## HISTORIC AND DESIGN REVIEW COMMISSION

### Agenda Item No: 16

**HDRC CASE NO:** 2015-204  
**ADDRESS:** 411 CEDAR ST  
**LEGAL DESCRIPTION:** NCB 2968 BLK 3 LOT 3  
**ZONING:** RM4 H  
**CITY COUNCIL DIST.:** 1  
**DISTRICT:** King William Historic District  
**LANDMARK:** Pfeiffer, A - House  
**APPLICANT:** Manuel Garcia  
**OWNER:** Robert Garcia  
**TYPE OF WORK:** Tax Certification, site work  
**REQUEST:**

### **Flatwork Plan**

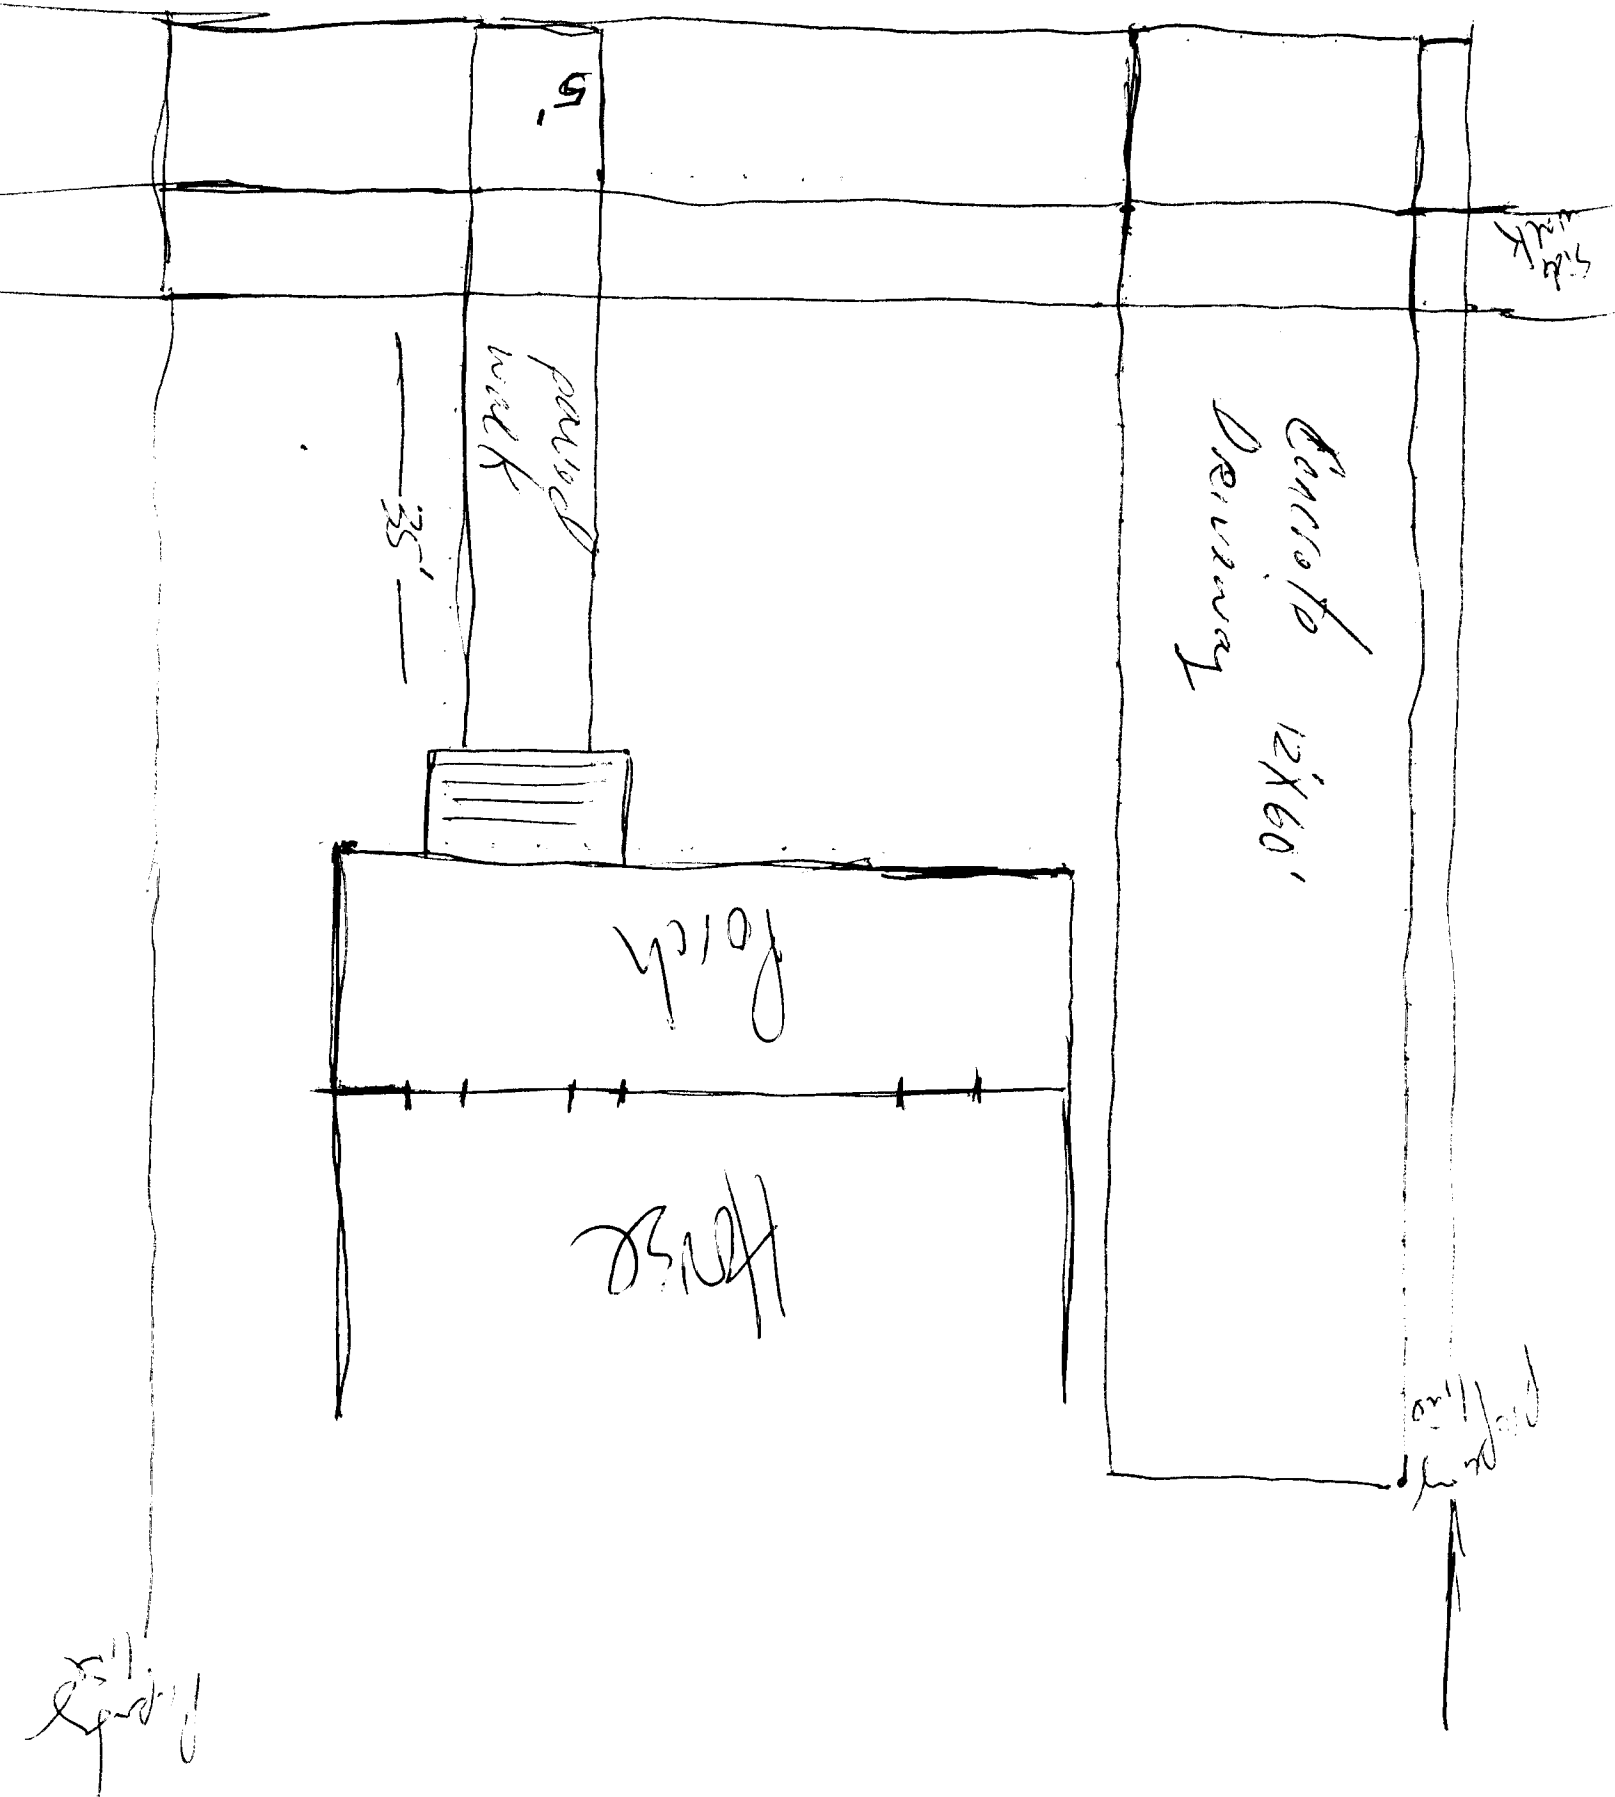
- a. The applicant has proposed to install a new concrete driveway where an existing informal driveway of dirt and loose gravel currently exists. The applicant has noted that the proposed driveway is to be 12 feet in width and 61 feet in length. According to the Guidelines for Site Elements 5.B., historic driveways are typically no wider than 10 feet. Curb cuts and approaches are often wider than historic driveways in order to accommodate a vehicle's turning radius, however this should not impact the width found historically on a particular property or throughout the district. Staff recommends that the applicant adhere to a driveway width of 10 feet.

- b. According to the Guidelines for Site Elements 5.A., repaired sidewalks and walkways should match the existing in color, materials, width and alignment. At a proposed width of 5 feet, the replacement walkway does not match the existing in width and is not consistent with the Guidelines. Staff recommends that the applicant retain the existing, historic walkway width.

Staff recommends approval based on findings a through e with the stipulation that the applicant retain the existing concrete sidewalk width and that the proposed new driveway be no wider than ten feet.
